CRASH INJURY BULLETIN

**MODIFICATIONS TO THE PASSENGER SEAT-BELT
TIEDOWN ATTACHMENTS IN THE**

U.S. ARMY HU-1 SERIES BELL IROQUOIS HELICOPTER

TCREC Technical Report 62-45

Figure 5. Suggested Interim Configuration.

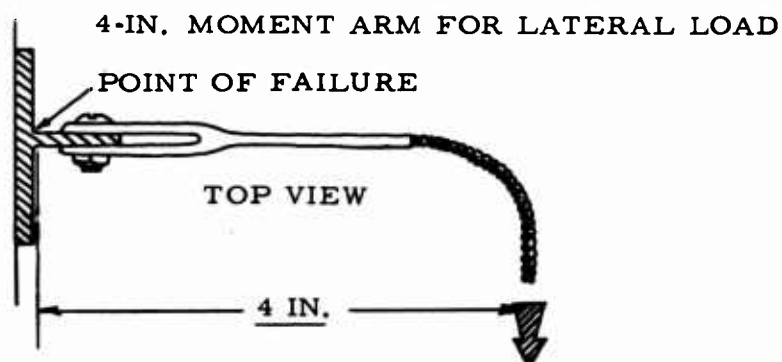
The present cable attachment provides a moment arm of approximately 4 inches when side loads are applied as shown in Figure 4. With this moment arm, only 800 inch-pounds (4 inches x 200 pounds) of direct side moment are required to break the attachment casting.

The 4-inch moment arm could be reduced to 1 inch if two "off-the-shelf" cable shackles were installed between the end of the cable terminal and the tiedown bracket, as illustrated in Figures 4 and 5.

This simple arrangement would increase side load capacity by 400 percent. It would also make the attachment omnidirectional and could be quickly installed in the field with available "off-the-shelf" components.

1. Separate the fork-end cable terminal from the tiedown bracket by removing the nut and bolt.
2. Interlock two cable shackles.
3. Using the same nut and bolt that held the fork-end cable terminal to the bracket, assemble one of the interlocked cable shackles to the bracket.
4. Disassemble the nut and bolt securing the ring coupling that is attached to the eye-end cable terminal and the seat-belt fitting, thus freeing the cable.
5. Reverse the cable, then insert the eye-end cable terminal in the remaining interlocked cable shackle and secure with the AN 25-14 bolt and AN 364-524A nut.
6. Insert the bolt that secured the ring coupling in the fork-end cable terminal and secure with its nut.
7. Attach the seat-belt snap hook fitting to the fork-end cable terminal at the bolt.
